Re: **NEW CAESAR RODNEY ELEMENTARY SCHOOL**  
Magnolia, Delaware  
2017073.00

### **ADDENDUM ONE**

The addendum forms a part of the contract documents and modifies the original bidding documents dated November 30, 2018, as noted below.

#### **2.7 INTERIOR DIE-CUT VINYL GRAPHIC**

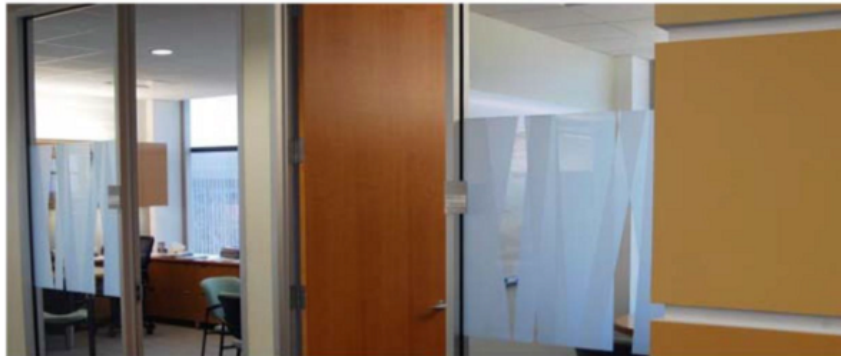
- b. ADD paragraph 1.5.D.4 as follows: “4. Vinyl graphic applied to glass.”
  - c. ADD paragraph 2.7 as follows:

- A. Type: Field-Applied, Vinyl-Graphics: Custom, full-color, die cut from 3- to 3.5-mil (0.076- to 0.089-mm) thick, vinyl film with release liner on the back and carrier film on the front for on-site alignment and application.
  - B. Substrate: Glass.
  - C. Size: As indicated.
  - D. Location: Media Center A125 at SF-15, SF-16, SF-17, and SF-18, and Mail A104 at SF-22B.
  - E. Graphics: To be supplied by Owner in vector file format during submittal review process. Examples of similar complexity are provided at the end of this Section.
- d. ADD paragraph 3.5 as follows:

**SKC-1**

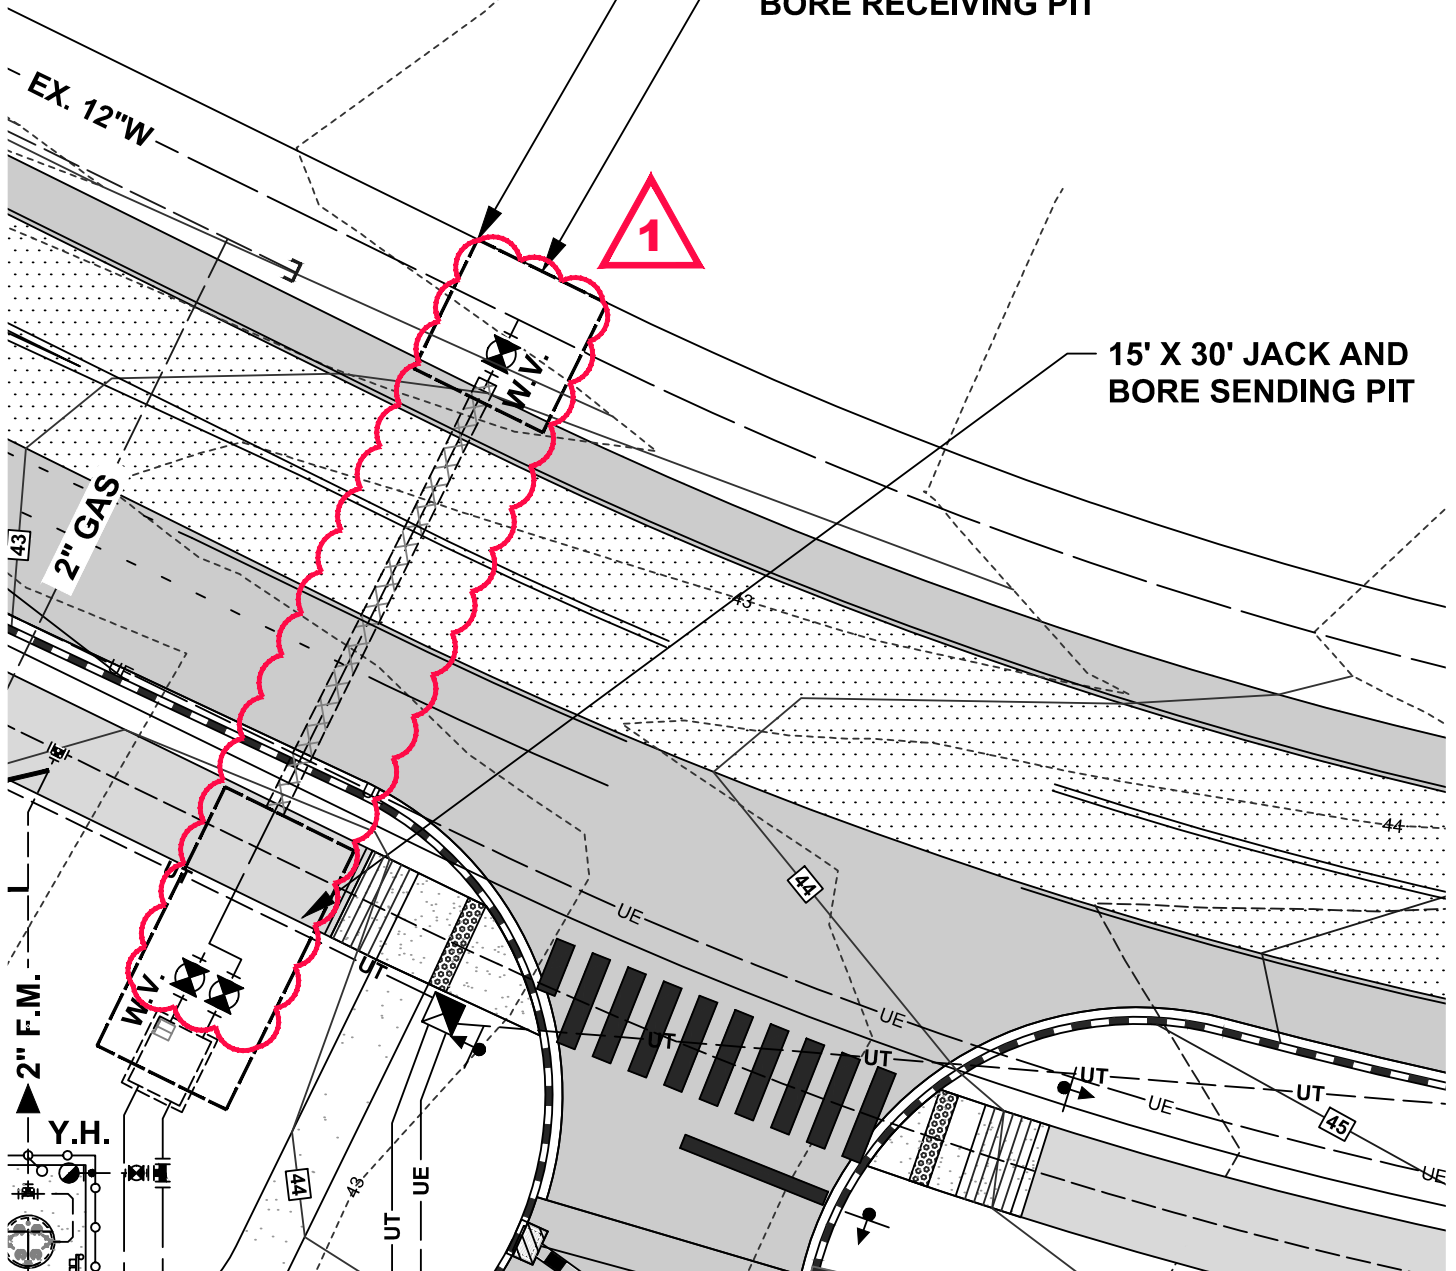
10. Where Architectural details note "GAGE PLATE", intent is for 16ga steel plate, hot-dip galvanized at exterior locations (under Section 055000).
11. Refer to attached sketch SKC-1, denoting limits of scope and other requirements concerning water service tie-in.

**NOTE: WATER SERVICE LABOR AND MATERIALS FOR PORTIONS WITHIN THE CLOUDED AREA ARE NOT IN CONTRACT. AN ARTESIAN APPROVED CONTRACTOR SHALL FURNISH AND INSTALL THIS PORTION OF WORK. THIS CONTRACT BEGINS AT THE DUAL VALVES SHOWN HEREON, TO BE INSTALLED ON-SITE, BY OTHERS.**

**JACK AND BORE METHOD  
WILL BE RECEIVED WITHIN  
DELDOT'S RIGHT-OF-WAY**

**15' X 15' JACK AND  
BORE RECEIVING PIT**

**15' X 30' JACK AND  
BORE SENDING PIT**
